SS 267-FCCC2021 eB2 High Voltage Relay

Certain 2020 & 2021 MY Electric School Busses "Jouley"

eB2 School Bus Jouley High Voltage Relay Replacement Procedure

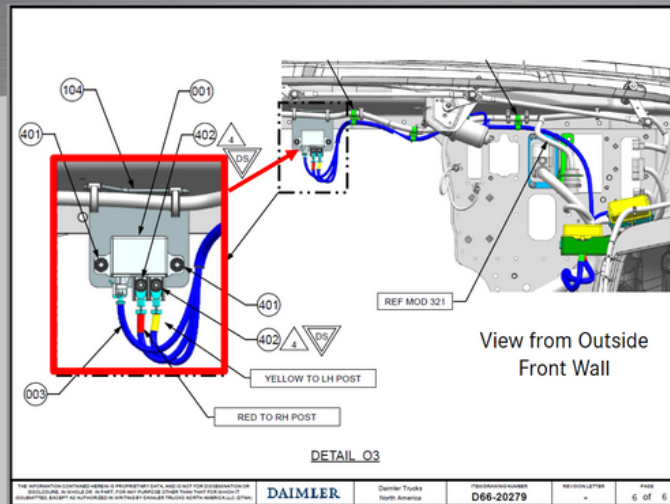
The High Voltage relay is currently rated as an IP65. While mounted in a dry location, some customer may want the added benefits of an IP67 rated module.

Replace High Current Relay with new relay with IP67 rating.

- Remove current relay replace with part number 06-96343-001

1. Decommission the vehicle per DTNA guidelines.
2. Disconnect the battery cables from the 12 volt batteries.
3. Disconnect the harness from the High Current relay, (item 003).
4. Remove the mounting hardware from the battery supply cables to the relay, (Item 402, yellow and red).
5. Remove the battery cables from the relay.
6. Remove the ¼ inch relay mounting hardware, (Item 401).
7. Replace the relay with new one, Part # 06-96343-001.
8. Torque mounting hardware, Item 401 to 5 Lb Ft
9. Reinstall the relay battery cables as indicated in the drawing, Red to RH post and Yellow to LH post and torque hardware to 3 Lb FT.
10. Reconnect the harness to the relay, (Item 003).
11. Reconnect the 12 volt battery cables.
12. Recommission the vehicle.
